INSPECTION REPORT  
Sedimentation Structure

J7-H

Black Mesa Mine  
Navajo County, Arizona

PEABODY COAL COMPANY

**SITE PLAN  
J7-H**

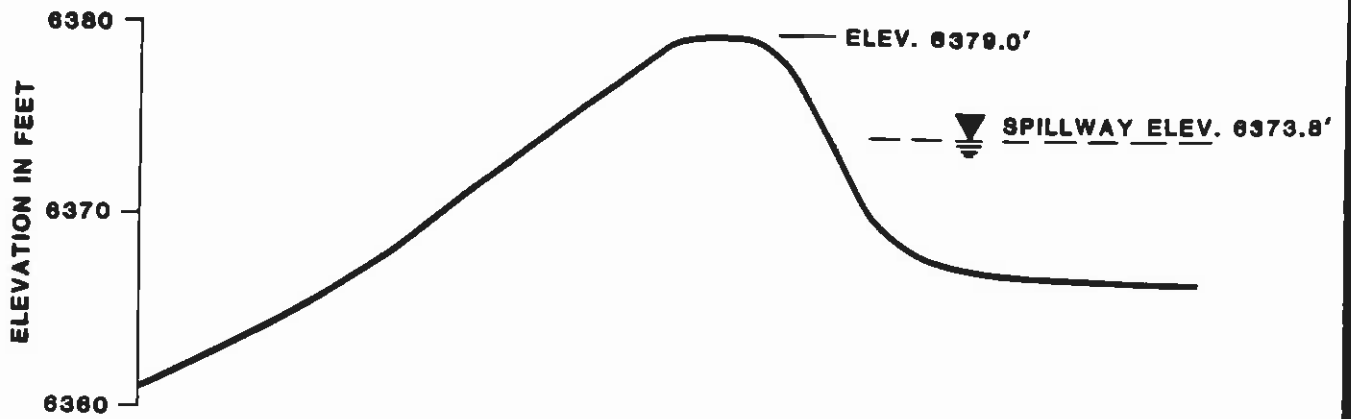
The storage capacity and spillway capacity of Structure J7-H are adequate; however, the spillway does not have an outflow channel or adequate erosion protection. A trapezoidal outflow channel should be constructed along the alignment B-B' shown in Plate 1. The channel profile is shown in Plate 4 and the required dimensions are shown in Plate 5. Both the spillway and outflow channel should be protected against erosion using geotextile and gravel as shown in Plate 5.
